O'Connor Park Playground Replacement Public Engagement Summary

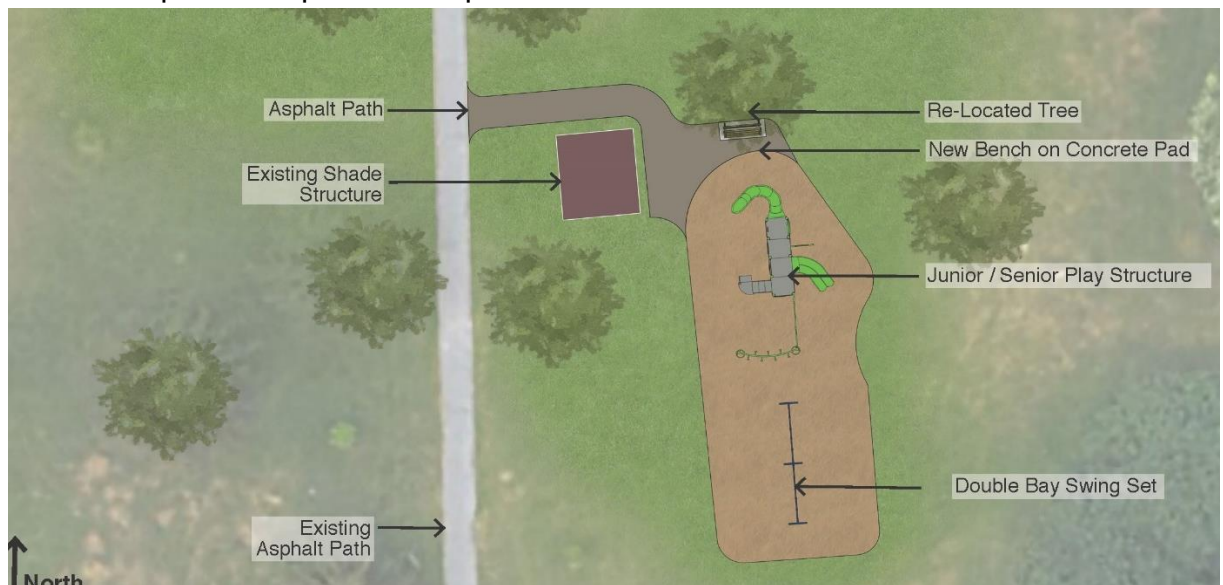
- 65% of respondents preferred Option 2

- It was indicated that the fireman pole was a favourite element on the old play structure, and that many are interested in a teeter totter
- Some respondents wanted more swings and had indicated that baby swings are important to young families
- A few respondents wanted a climbing cage or a net climber
- A few respondents wanted natural play equipment like stepping rock paths, logs, and natural climbers
- A respondent questioned if there is even enough use to justify a new playground, while another respondent was glad to see improvements finally taking place in the park

- Some feel that having separate playground areas is better for separating the age groups, providing more space on busy summer weekends, or for COVID related concerns, while on the other hand, it is harder to supervise
- There were varying opinions on the existing condition and salvation of the old senior structure, junior structure, and baby swings
- One respondent suggested keeping the sand safety surface as kids like to play in it

- Option 2 will be implemented and a fireman's pole and teeter totter will be added in response to feedback.
